MONITORING YEAR 2 ANNUAL REPORT

GLADE CREEK II RESTORATION PROJECT

Alleghany County, NC
DEQ Contract 6843
DMS Project Number 92343
USACE Action ID 2009-00589

RE: Response to MY2 Draft Report Comments
Glade Creek II Mitigation Project
DMS Project # 92343
Contract Number 6843
New River Basin - #CU# 05050001 - Alleghany County, North Carolina

Figure 3 Integrated Current Condition Plan View
 Glade Creek II Restoration Project
 DMS Project No. 92343
 Monitoring Year 2 - 2017

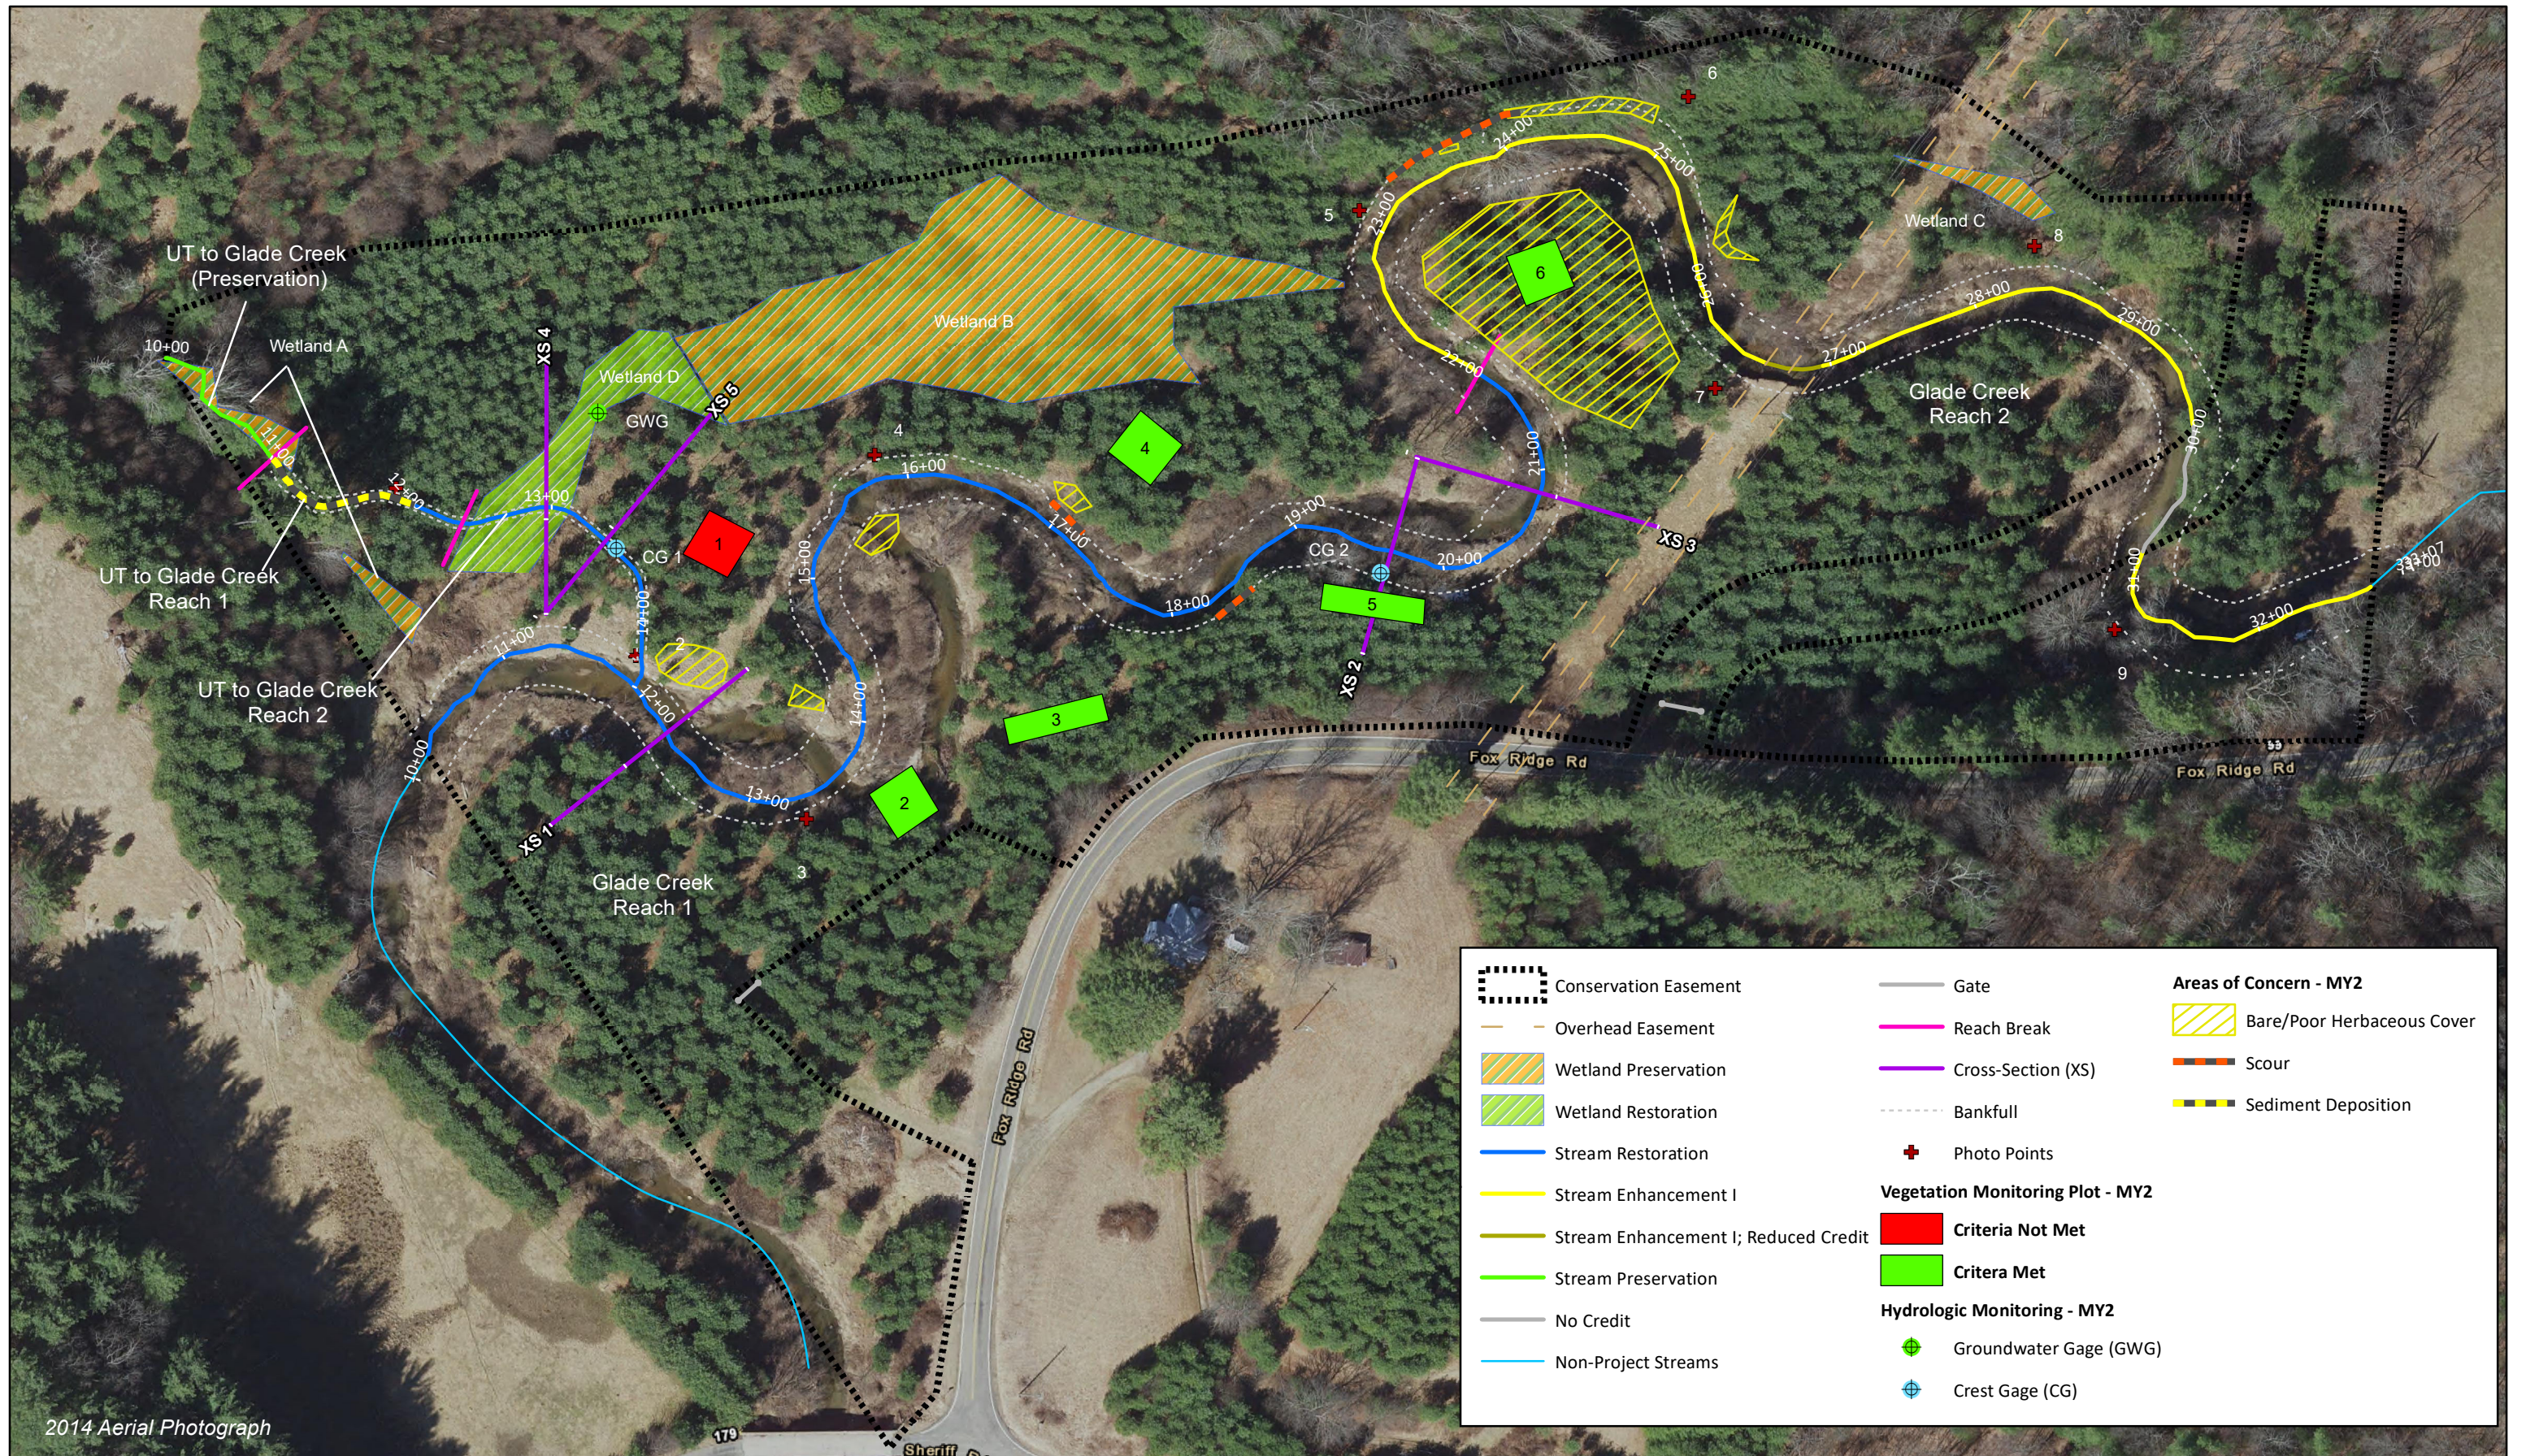
DMS comment; Stationing on maps for the UT (0+00 to 3+45, starting at the restoration reach) do not match stationing numbering with the asset table (10+00 to 14+48 starting at the preservation reach); in addition, Reaches 1 and 2 on the CCPV figures appear incorrectly labelled (fig. 3) or unclear (fig. 2). Please clarify or correct.

Wildlands response; Wildlands has revised both the Asset Table 1 and the figures stationing to accurately represent the reaches on UT to Glade Creek.

UT Glade Creek (STA 11+29 - STA 14+48)

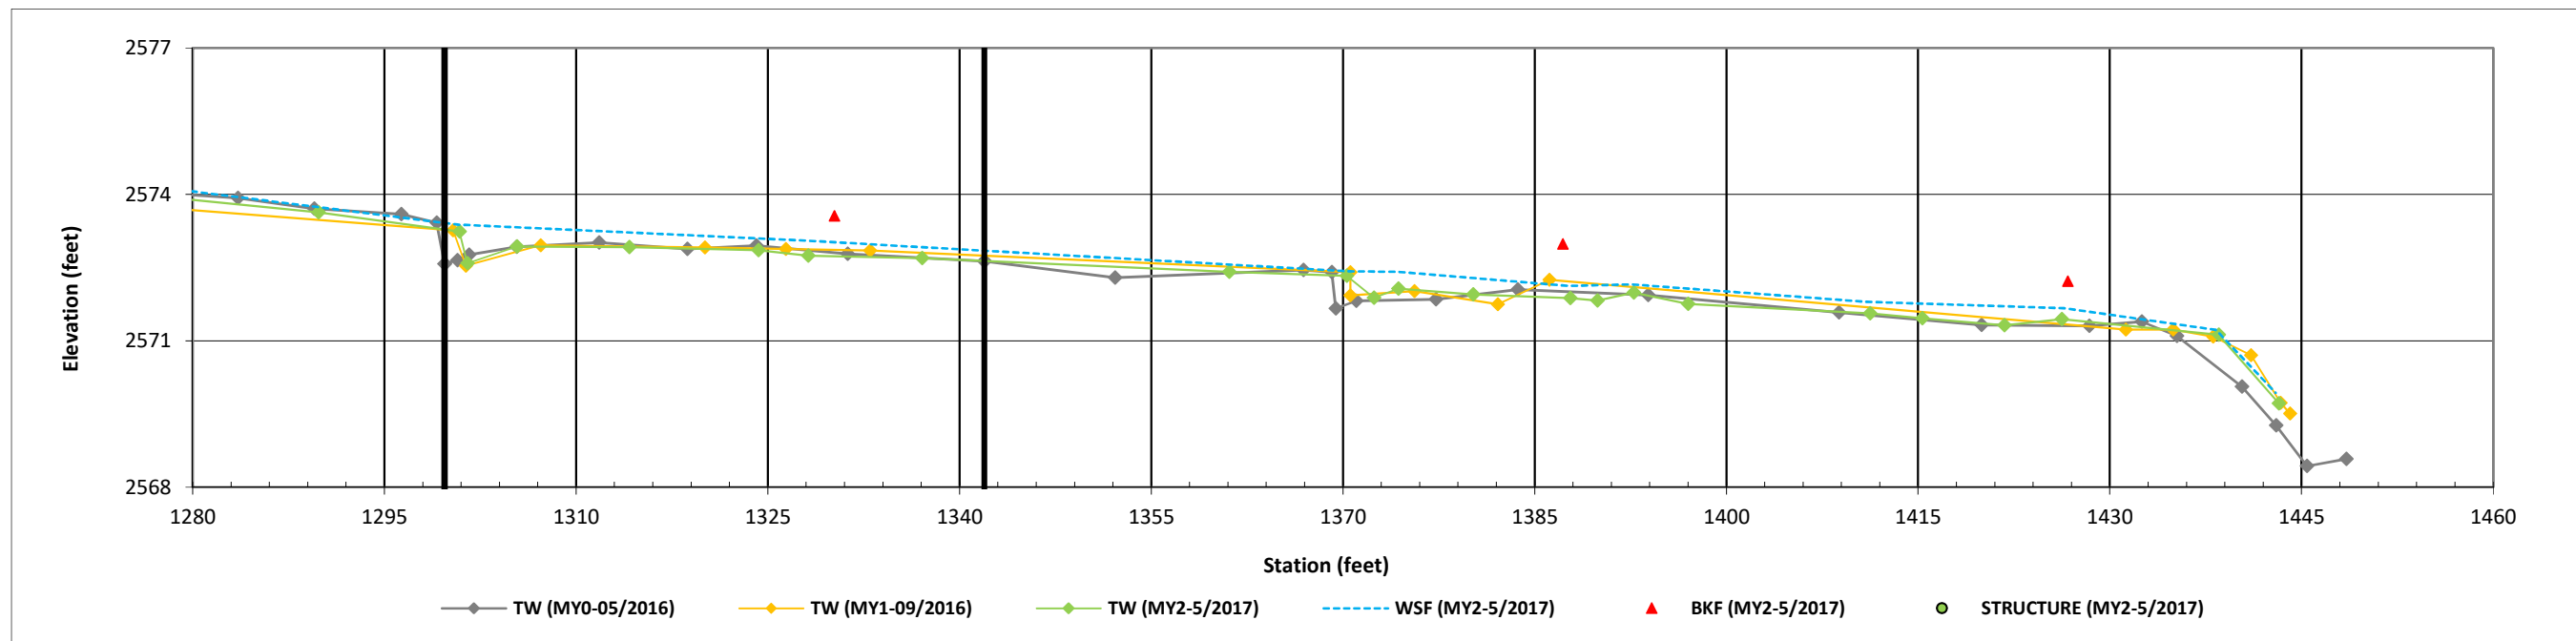
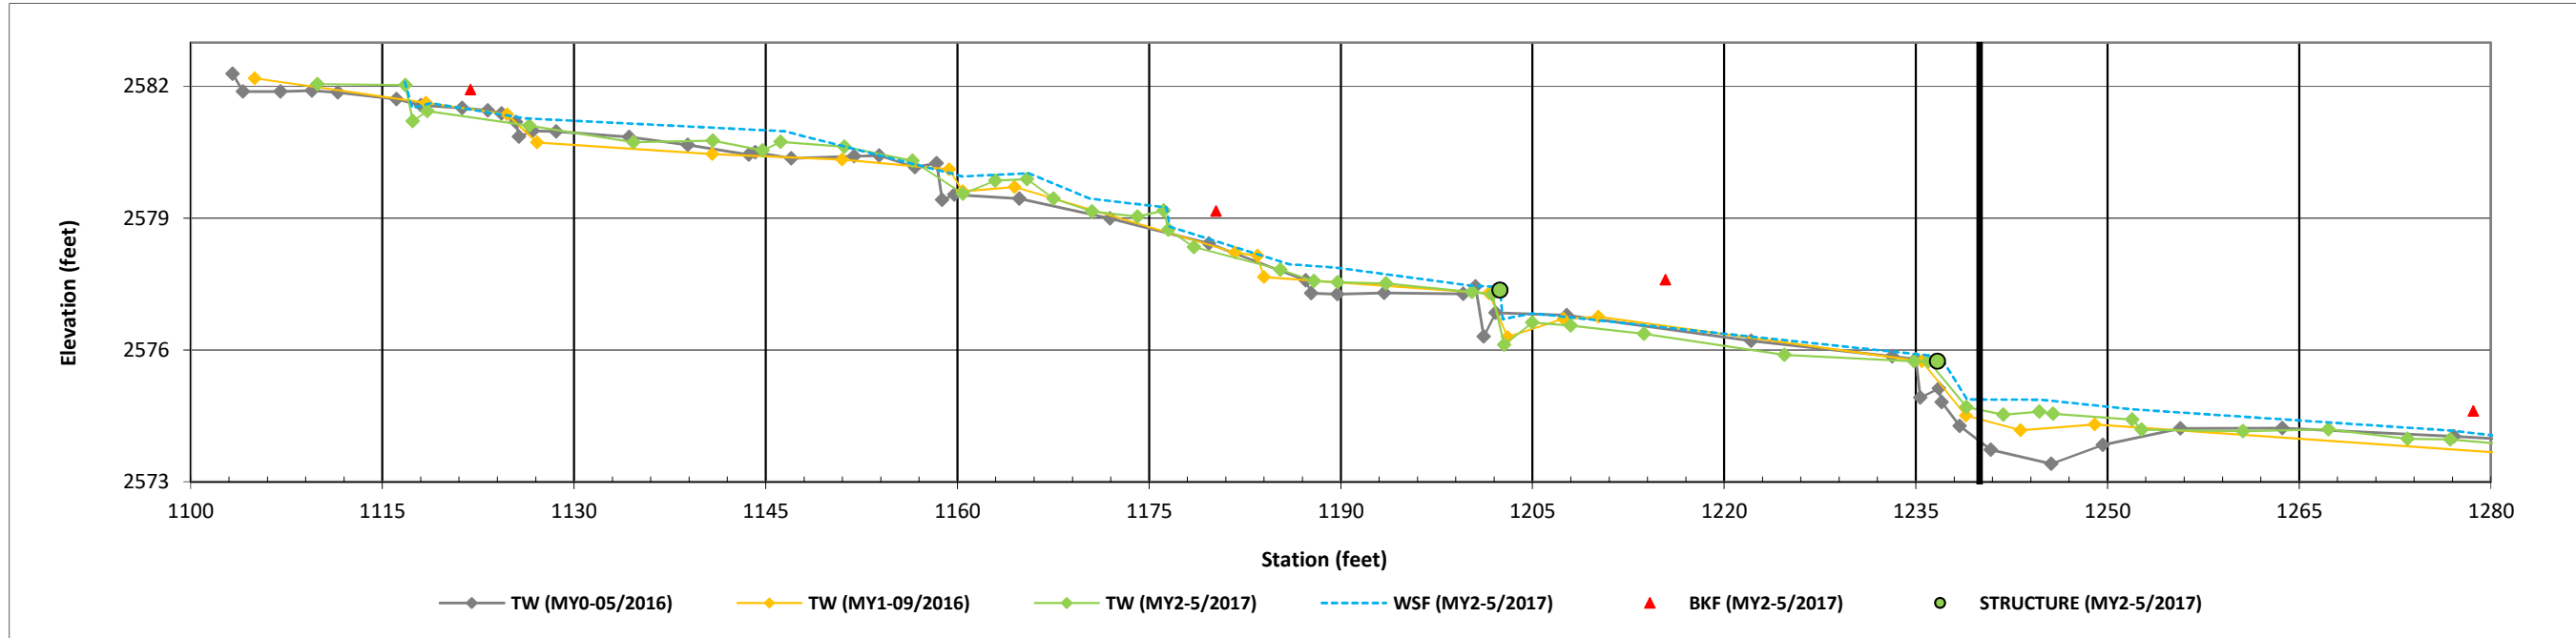
DMS comment; Changing the vertical scaling on the longitudinal profile for the Ut would help show more subtle changes in the profiles.

DMS comment; Long-pro plot for the UT appears upside down in the hard copy. Please make sure any printed copy graphs and pages read right side up when printed.

Wildlands response; Longitudinal profile vertical scaling has been revised for UT to Glade Creek as requested above.

Wildlands response; Hard copies of the Final Monitoring Report will be corrected for this issue.
